## 2020 Annual Update - Small Areas

### EPC Review - Hearing January 21, 2021

### 3-6(D) COORS BOULEVARD – VPO-1

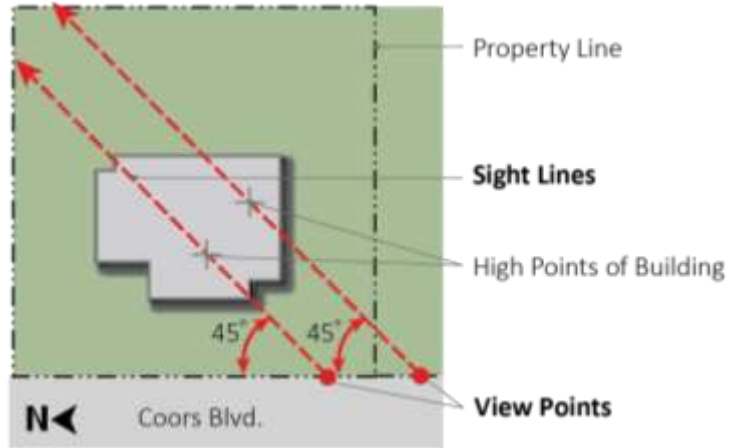
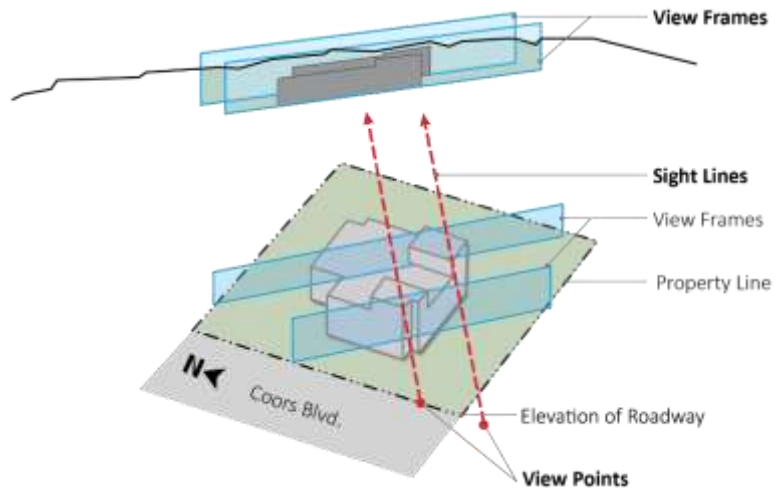
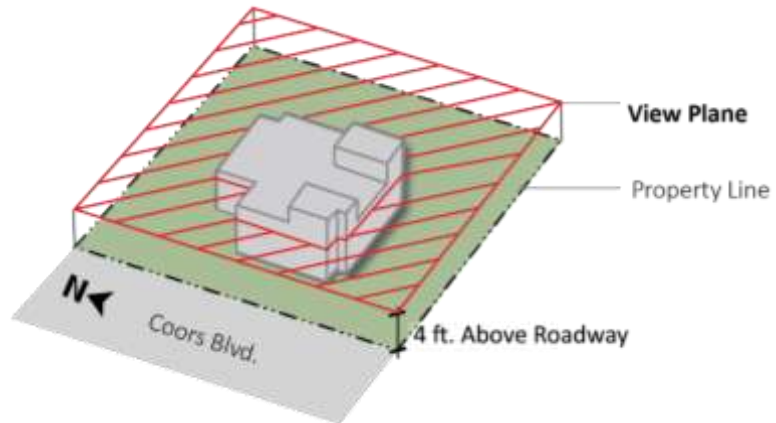
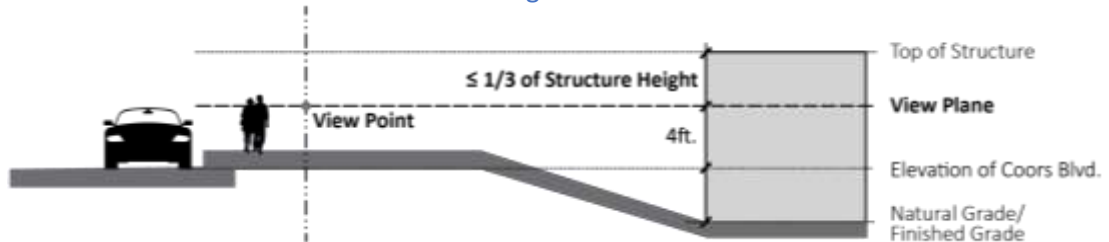
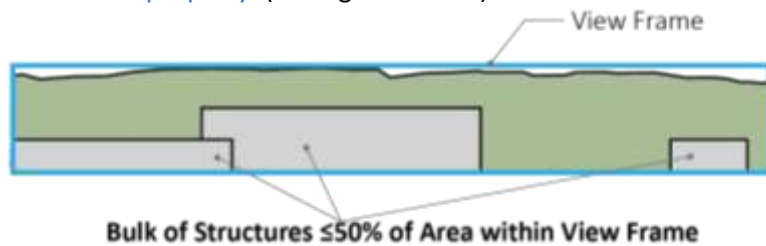
| Page | Section          | Change / Discussion  | Explanation  |
|------|------------------|--|--|
| 130  | 3-6(D)           | Coors Boulevard VPO-2<br>Revise as shown in Exhibit 3-6(D) - Coors Boulevard VPO-2.  | Incorporates changes proposed with the 2019 IDO update and clarifies issues raised during the EPC process in 2020. Generally, these changes specify what view is protected, the view point that view is taken from, defined terms, and more specific methodology about how to perform the view analysis. The changes clarify that the sight line is used for both the building height and bulk analyses and that more than one sight line may be required. Finally, minor revisions to the graphics are proposed to add clarity. See Exhibit 3-6(D).   |

1. Lines that begin at each view point along Coors Boulevard, looking toward the ridgeline of the Sandia Mountains at a 45 degree angle from the east edge of the roadway.
2. Sight lines are required to intersect the highest point(s) of the proposed building(s) on the site. If the building has no higher point is all the same height, a sight line shall begin at a view point at the lowest elevation(s) of the public right-of-way of Coors Boulevard abutting or nearest to the site that allows the sight line to pass through the building.
3. The sight line is used as the perspective for the analysis in Subsections 14-16-3-6(D)(5)(a) (Building Height) and 14-16-3-6(D)(5)(b) (Building Bulk). Multiple sight lines may be required depending on the size of the site and shape of the building(s). (See figure below.)

A vertical rectangular frame drawn perpendicular (i.e. 90 degrees) to a given sight line **through the highest point of the proposed building**. The top of the view frame is established by the highest visible point of the Sandia ridgeline within the view frame. The bottom of the view frame is the elevation of the public right-of-way of Coors Boulevard where the sight line begins. The left and right edges of the view frame are an upward projection of the property lines at the site boundary where the view frame intersects the property lines. As many view frames as necessary to capture all the sight lines on a site are required. (See figure below.)

A **horizontal view** plane 4 feet above the elevation of the east edge of the east driving lane on Coors Boulevard, **based on the elevation of the view point for a given sight line, and extending horizontally above the sites located east of Coors Boulevard considering the perspective that would be seen along the sight line. Multiple view planes may be required if the elevation of Coors Boulevard varies across the site.** (See figure below.)

No more than 1/3 of the height of structures (including building parapets, mechanical equipment and associated screening, walls, and fences) shall be allowed to penetrate above the view plane as seen along each sight line and as shown in section diagram below, with the following exceptions:
